# Northlake : Bulk Earthworks Stages 8-9

## **Northlake Developments Water Supply Modelling**

## NORTHLAKE DEVELOPMENT STAGES 1-7

Purpose & Drawing Title:  
**Northlake Stages 1 - 11  
Primary Watermains**

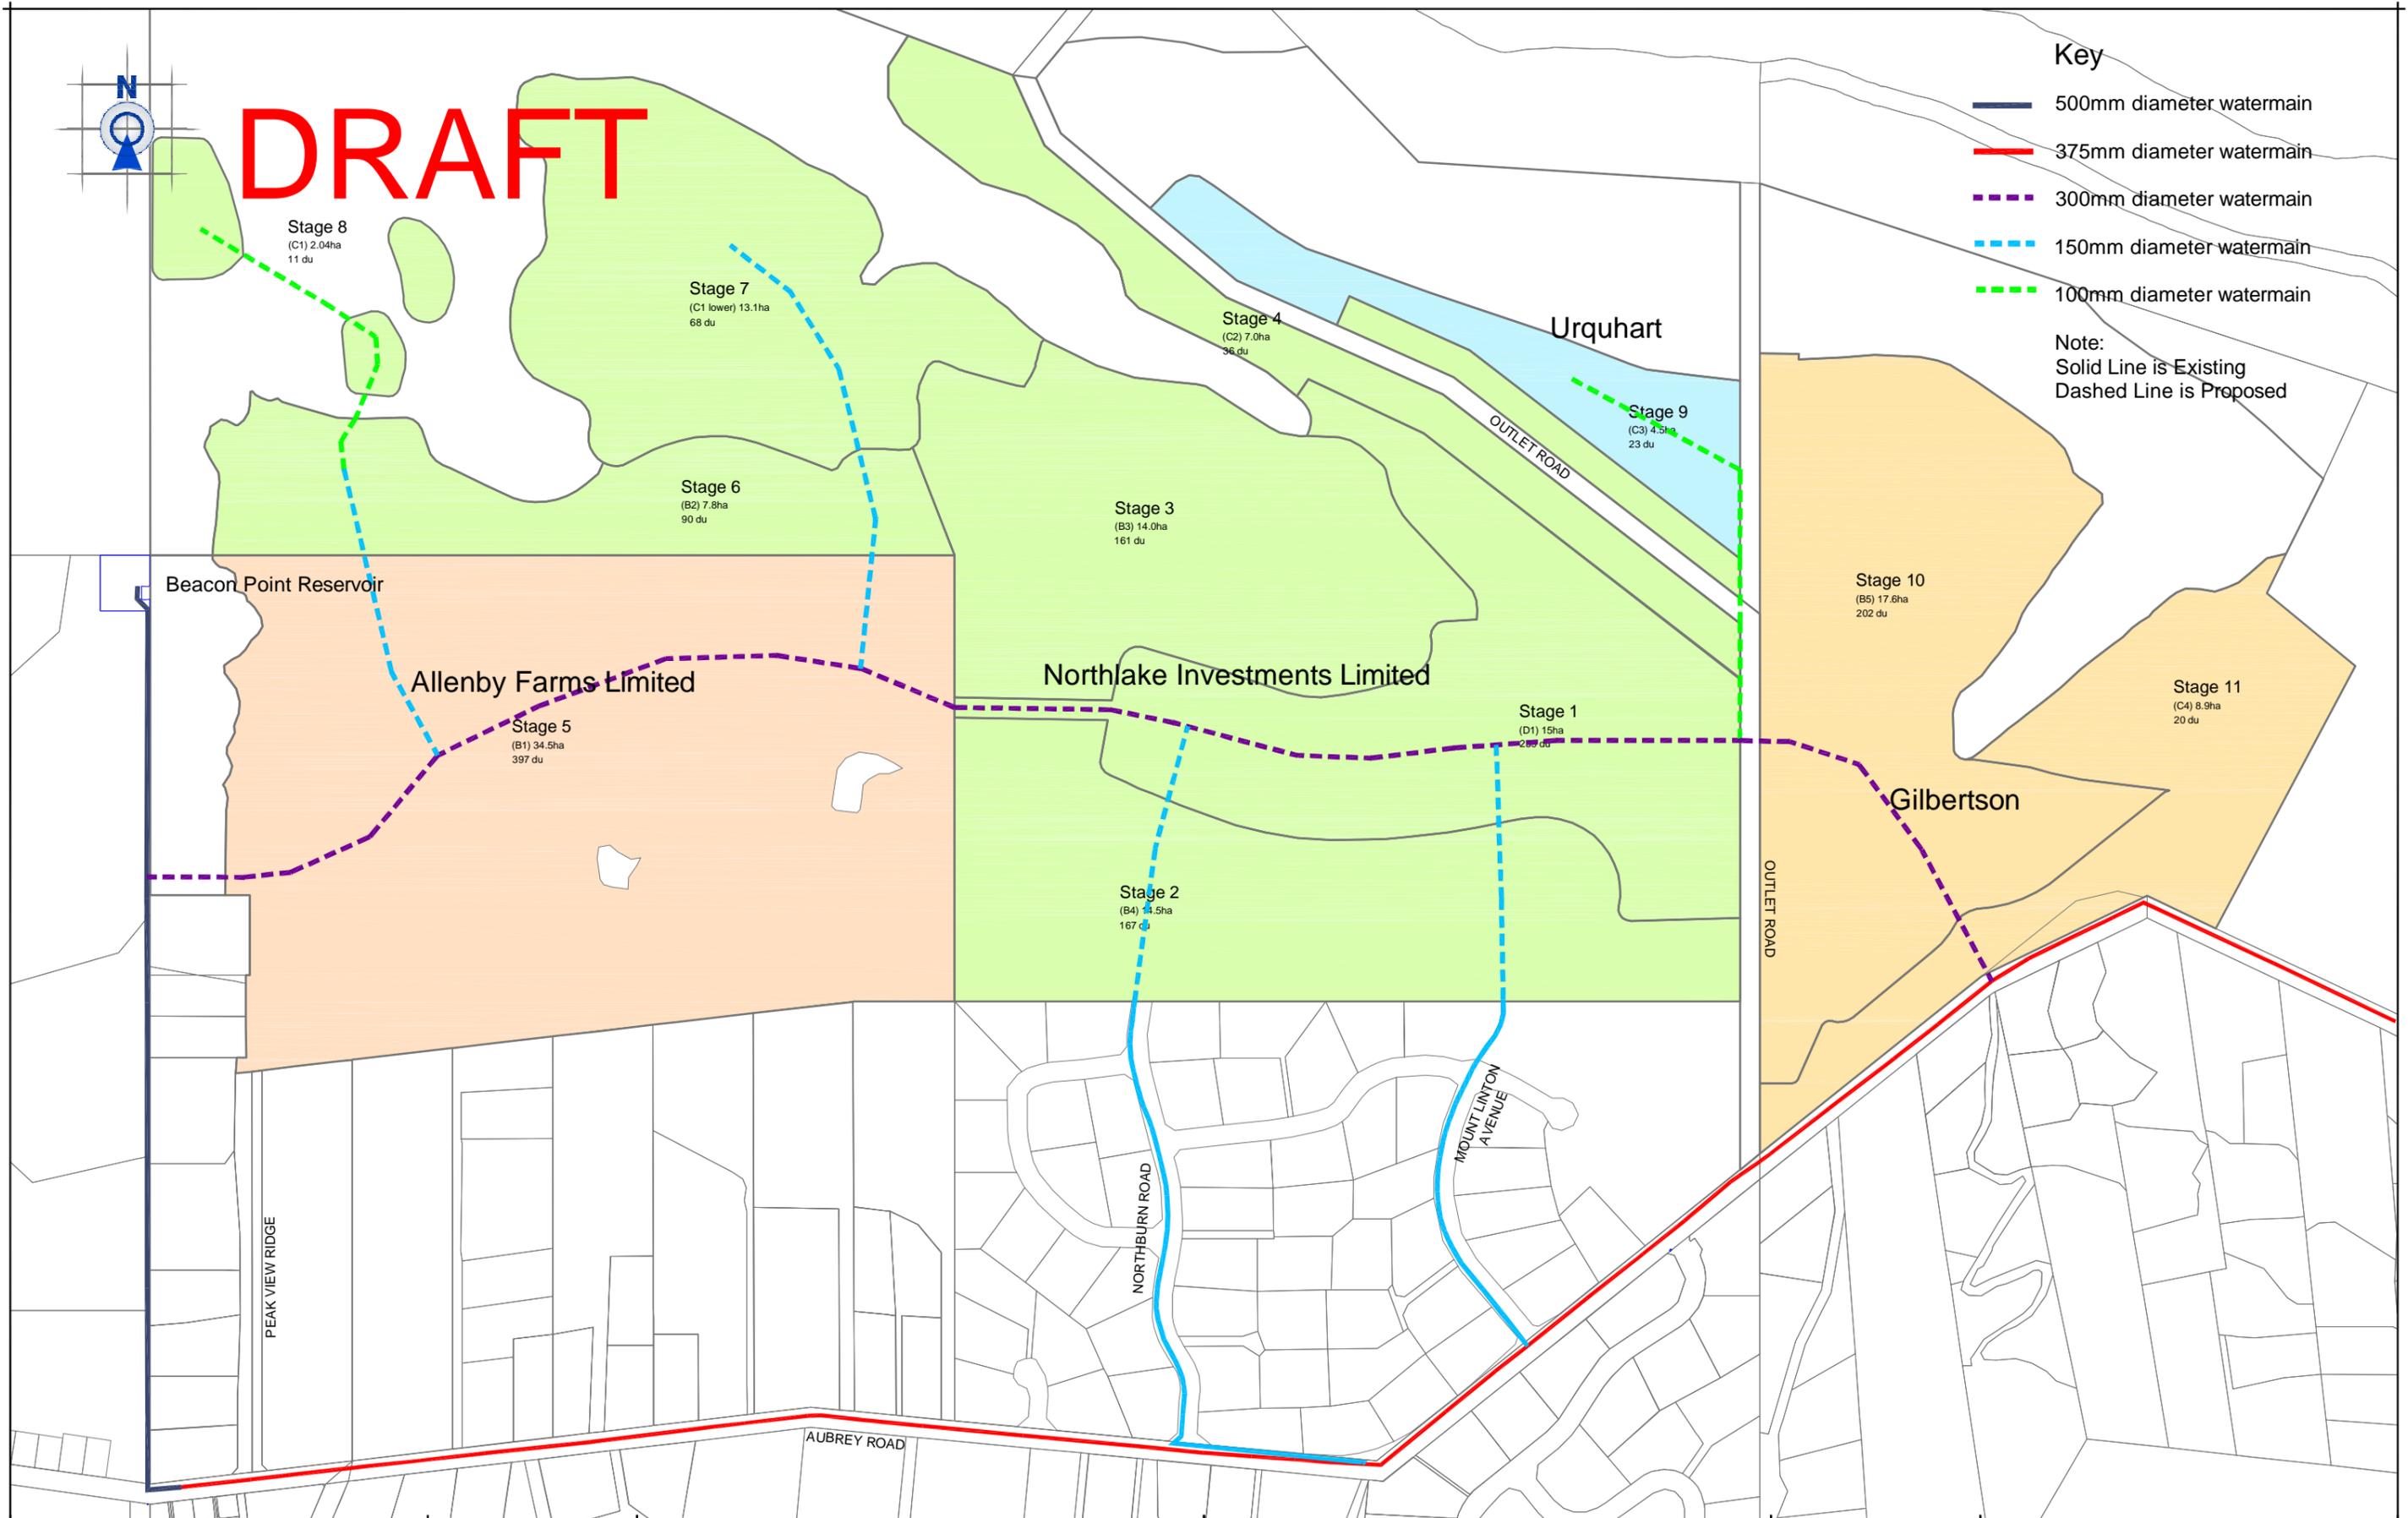
As per your request, we have undertaken hydraulic modelling to review the proposed water supply layout provided by Patterson Pitts Group, with respect to achieving the levels of service required by Queenstown Lakes District Council.

The demand has been assessed based on the Northlake Stages 1-7 Proposed Water Supply Layout drawing W4481-7 011 Rev3 and the Queenstown Lakes District Council Land Development and Subdivision Code of Practice (2015).

For current peak day demand, pressures within the new sub-division are above 300kPa. The firefighting classification of 50L/s is easily achieved. The proposed pipes have head loss per unit length under 2 m/km or only slightly over.

The modelling results indicate the proposed new development can be supplied through the proposed reticulation layout and meet the desired levels of service indicted by Queenstown Lakes District Council. Provided Queenstown Lakes District Councils are comfortable with the level of service provide to the properties on Glenaray Road, the proposed water supply design should be accepted.

Ultimate Development  
Water Supply Reticulation  
- with additional inlet pump

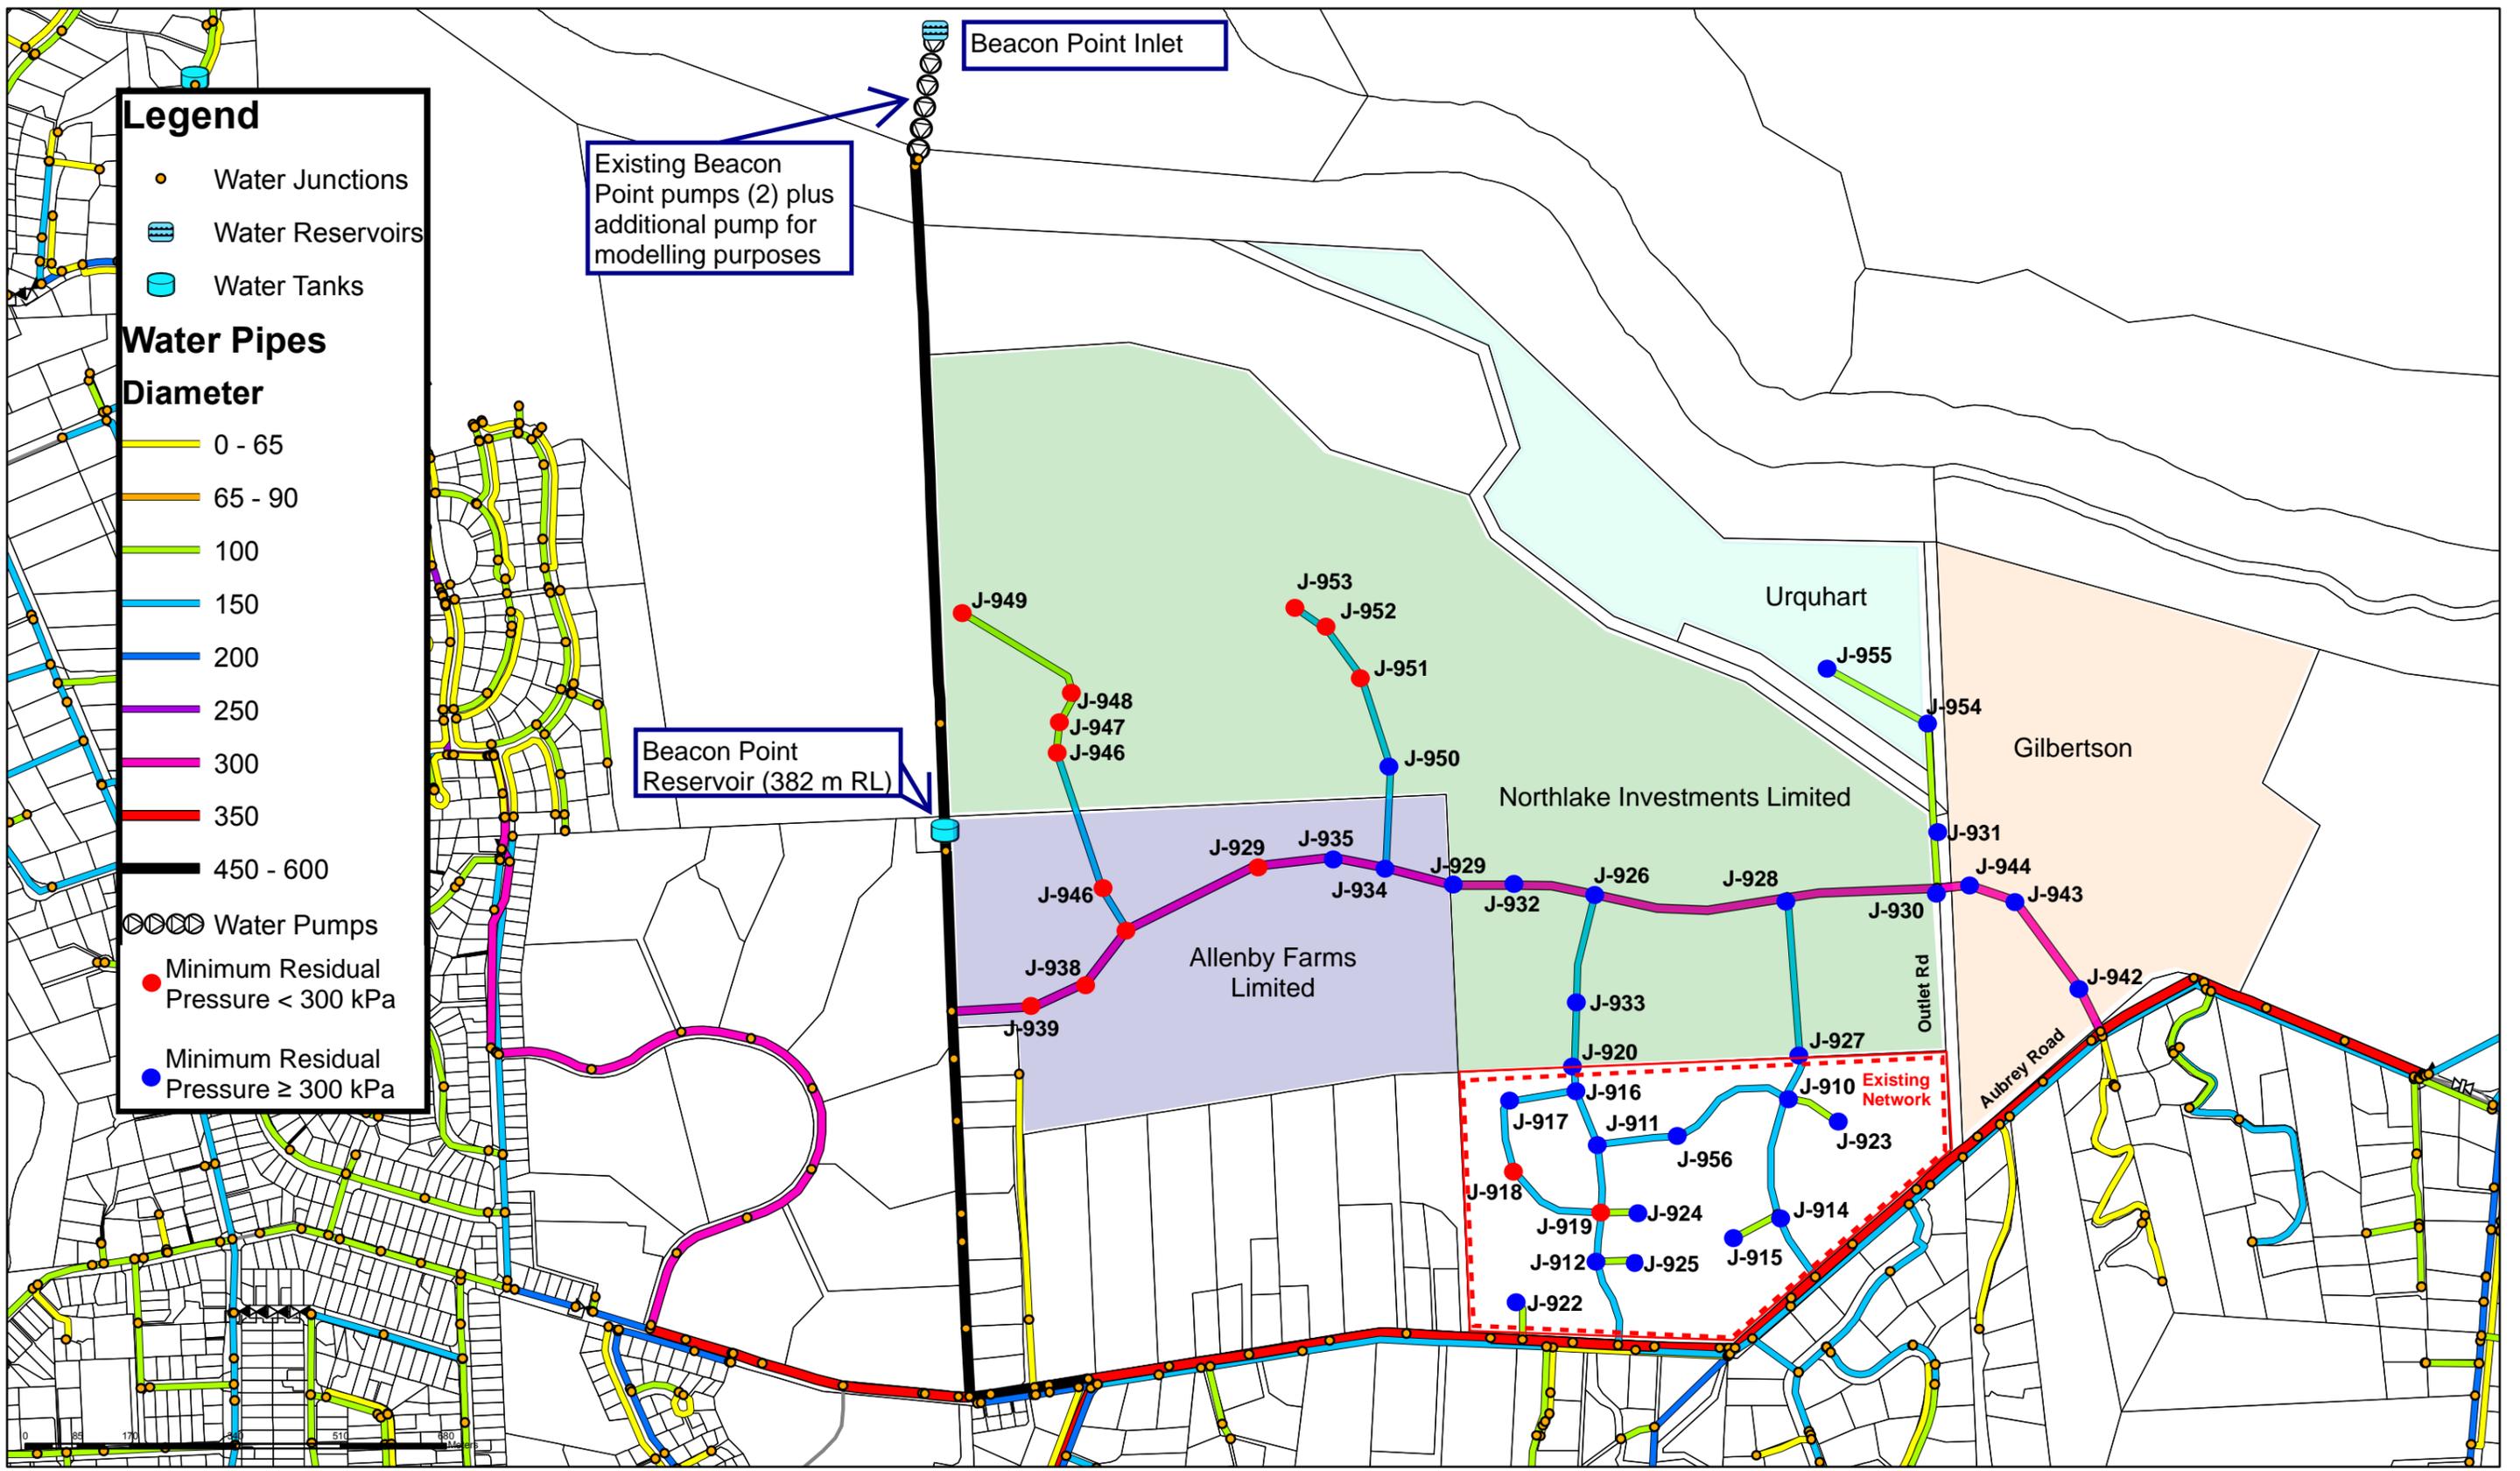
Modelling indicated that with the additional demand for the ultimate development on top of current network operations, the Beacon Point reservoir would drain to empty towards the peak hour of the day without further network upgrades. This means levels of service are unable to be met throughout the ultimate development without upgrades to the current network.

With the third operational pump at the intake, the required levels of service and firefighting flows in the area were not achieved for the higher areas in the development due to the elevation difference with the Beacon Point Reservoir (refer Appendix D). Table 3 below details the minimum residual pressures and fire flows achievable at each modelled junction in the development.

The results show that with three operating pumps, the required network demands and levels of service are achievable for the Gilbertson and Urquhart developments and Stages 1-4 of the Northlake Investments Limited development. However, due to the high elevation of the Allenby Farms Ltd development and Stages 6-8 of the Northlake Investments Ltd development, the same requirements cannot be met without localised pressure boosting or an additional upper reservoir. In general, this applies to all development and network connections at or above 355 m RL.

Provided the increased network demand can be met by Beacon Point intake (i.e. an additional operational pump at the Beacon Point intake), levels of service can be met within the development for the proposed areas below 355 m RL (i.e. Stages 1 - 4 and 9 - 11). Localised boosting (i.e. pump stations and/or upper reservoir) to areas of higher elevation (i.e. Stages 5 – 8) in the proposed development and isolated areas in the existing Northlake development network is required to enable levels of service requirements to be met.

The proposed development pipe network capacity is adequate for the design demands modelled and when combined with pressure boosting measures (to overcome the elevation difference between the development area and the Beacon Point Reservoir). Specific pressure boosting measures (i.e. upper reservoir and/or pump station(s)) have not been modelled.
